Riley-Purgatory-Bluff Creek Watershed District
Board of Managers Regular Meeting
Wednesday, August 5, 2020, 7:00pm Regular Meeting
Virtual Meeting via ZOOM

Agenda

Permit Location Map
7420 CHANHASSEN ROAD
Permit 2020-041
Riley Purgatory Bluff Creek
Watershed District

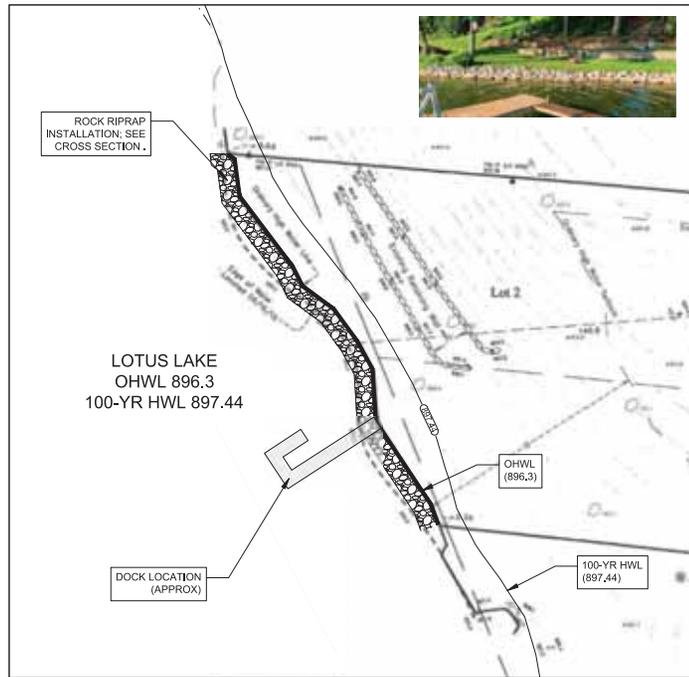
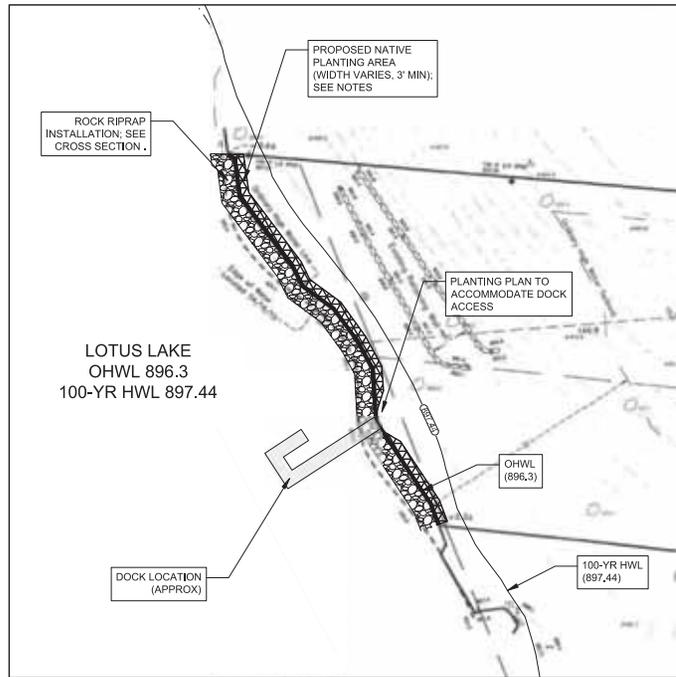
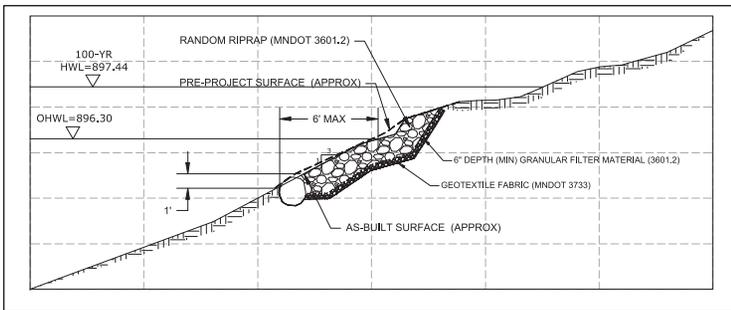
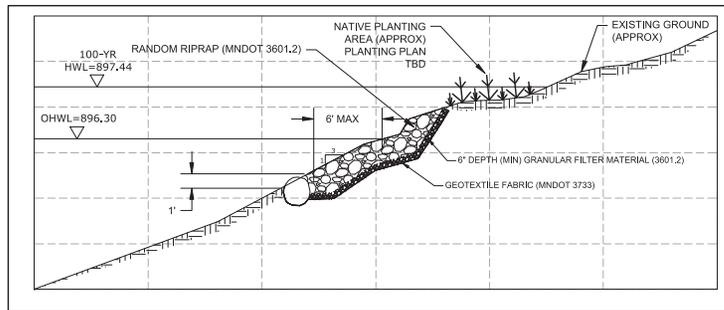
1. The applicant is requesting after the fact approval for the installation of riprap along 140 feet of Lotus Lake shoreline.
2. The application is considered incomplete because of missing information needed to assess compliance with RPBCWD's floodplain, erosion prevention and sediment control, and shoreline and streambank stabilization rules.
3. The project will conform to Rules B, C, and F if the rule specific comments detailed above are addressed.
4. Under Minnesota Department of Natural Resources General Permit 2015-1192 (attached to this report), approval of work under RPBCWD rule(s) F constitutes approval under applicable DNR work in waters rules. Compliance with conditions on approval and payment of applicable fees, if any, are necessary to benefit from general permit approval and are the responsibility of the applicants.

7. Receipt of an updated as-built drawing that resolves the apparent inconsistency between the dimension labeled and the vertical axis on the both cross sections. The cross section lists a dimension of 2 feet but the vertical axis indicates about 6 inches. Please revise the dimension or vertical axis for consistency and confirm that the toe boulders were installed at least 50% buried and at least 1.25 times the maximum stone diameter (Rule F, subsection 3.3iii).
